Addendum 4

Rentschler Field Roof Replacement

CRDA Project #25-024

- The following ARCHITECTURAL drawings have been deleted in their entirety, and new drawings have been added and are attached as part of this addendum.* (9) (Per RFI #006)

Drawing Title:
TOWER ROOF DEMOLITION PLAN

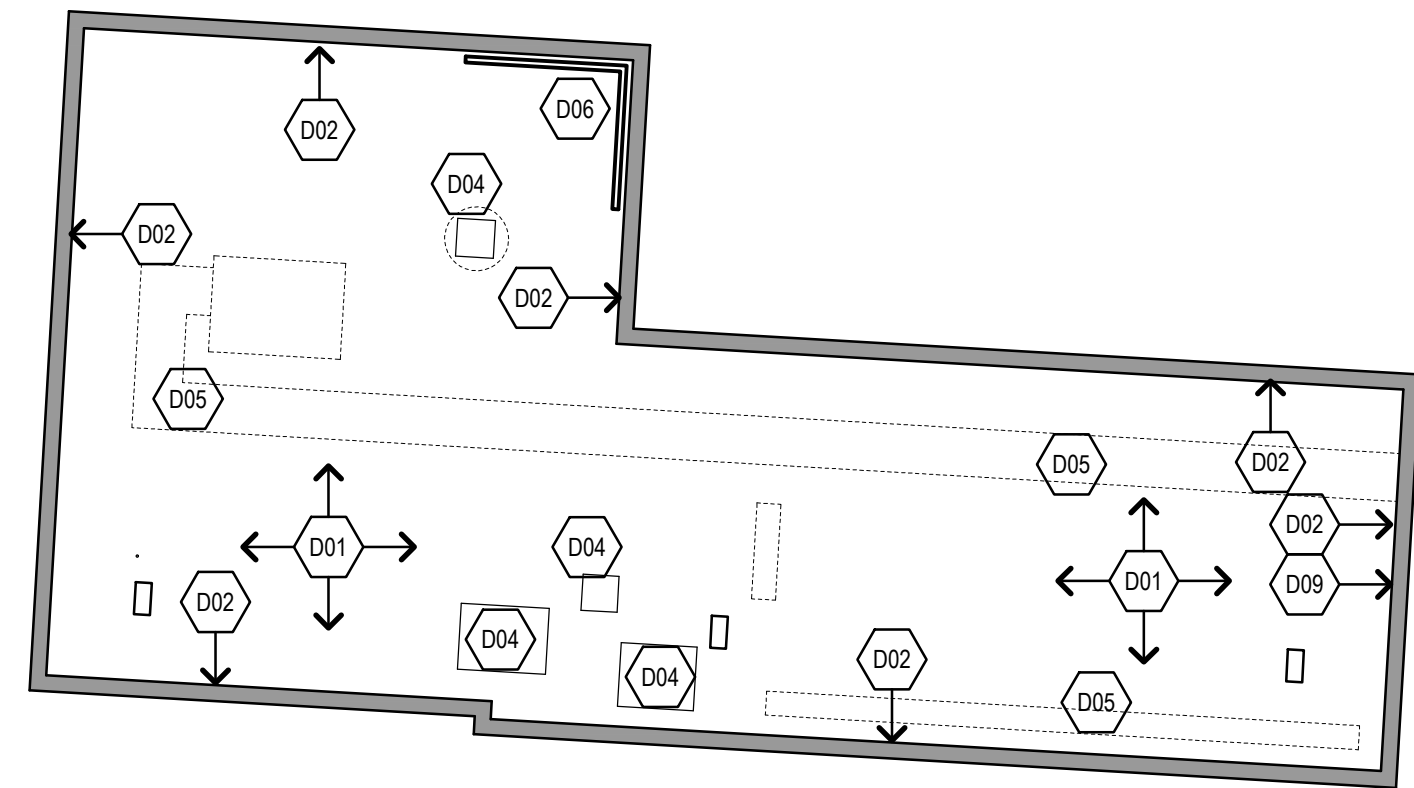
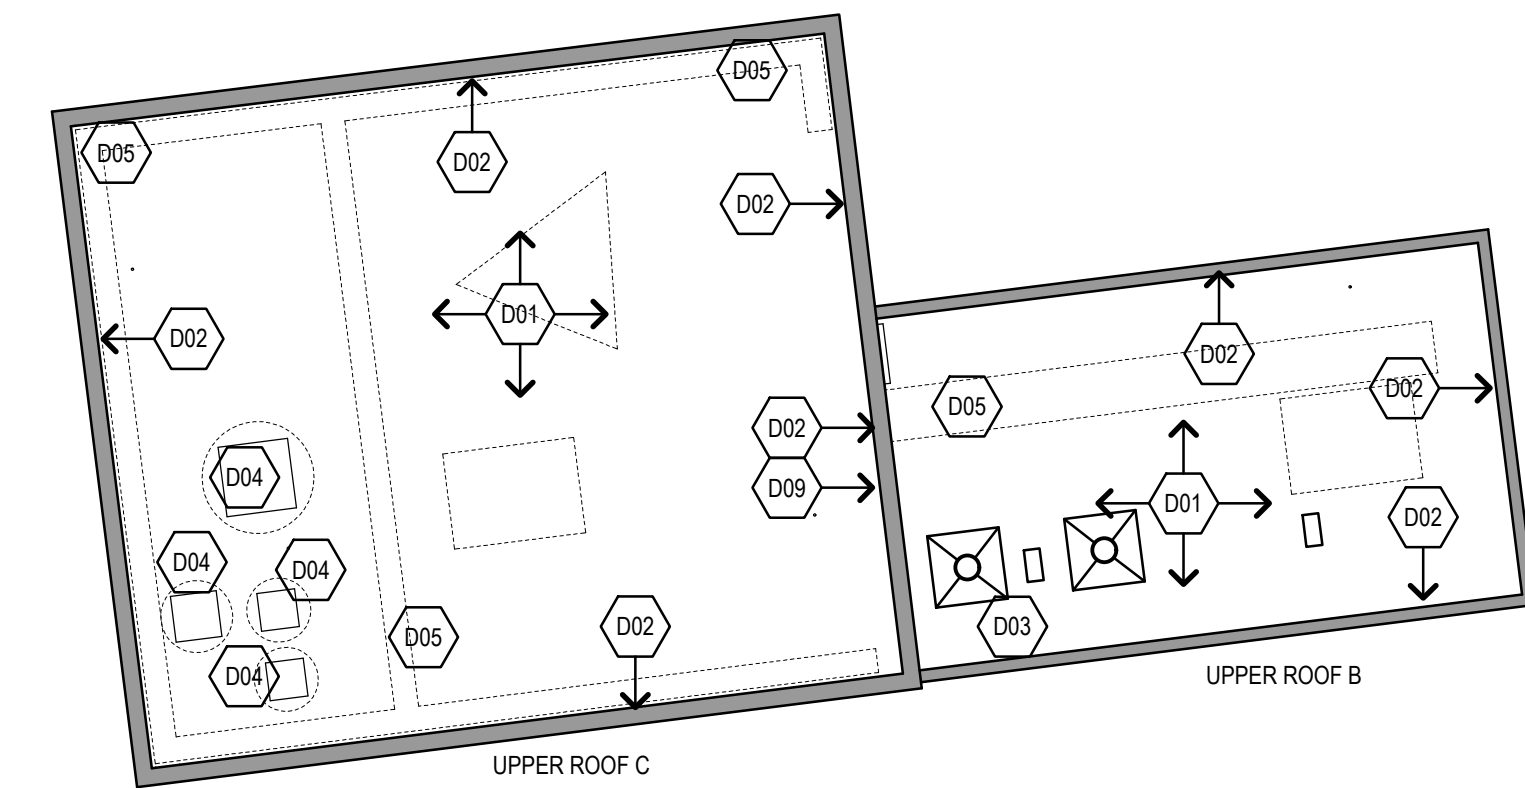
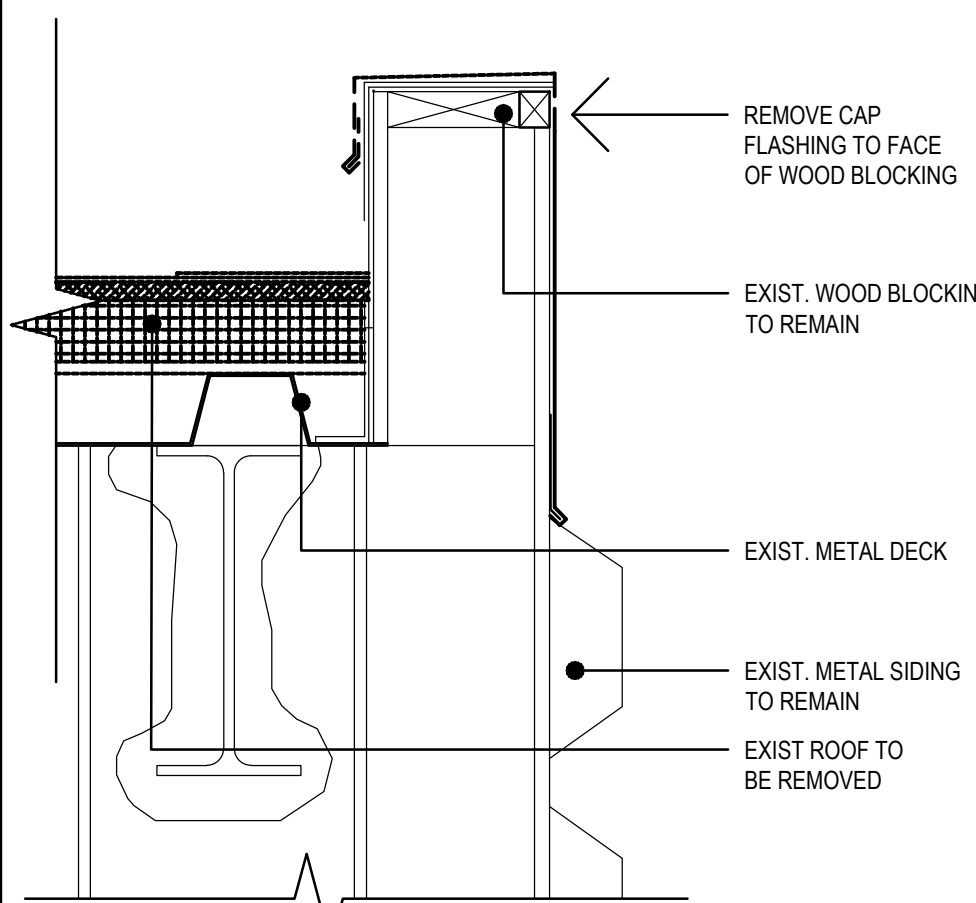
RFI #	QUESTION	DATE RECEIVED	RESPONSE	ADDENDUM # ISSUED
001	Page 3 of the invitation to bid under scope of work #2 states metal ladders to be removed and replaced. Page A002 of the drawings under demolition note #7 states to remove and retain for reinstallation. Please confirm which is correct.	05/01/25	Note #7 refers to the metal stairs that are part of the platform on Roof A-2 (to the west of Roof C) and the stairs to the machine room on Roof A-1 (to the north of Roof D). These stairs are to be removed and reinstalled with appropriate adjustments as needed.	2
002	Regarding something on the overall roof plan (A100). Littered throughout the roof are the abbreviations "PP" which according to the symbol legend stand for pitch box. I have attached a copy of A100 where I have circled a bunch of these abbreviations but not all. We would like to know if there truly needs to be this number of pitch boxes spread throughout each roof section or if this is a mistake. This seems like an excessive amount of pitch boxes and not typically normal to see this number of them on a roof.	05/02/25	There are upwards of 100 pitch pockets (PP), and all are required. Contractor to verify exact number and location in field.	2
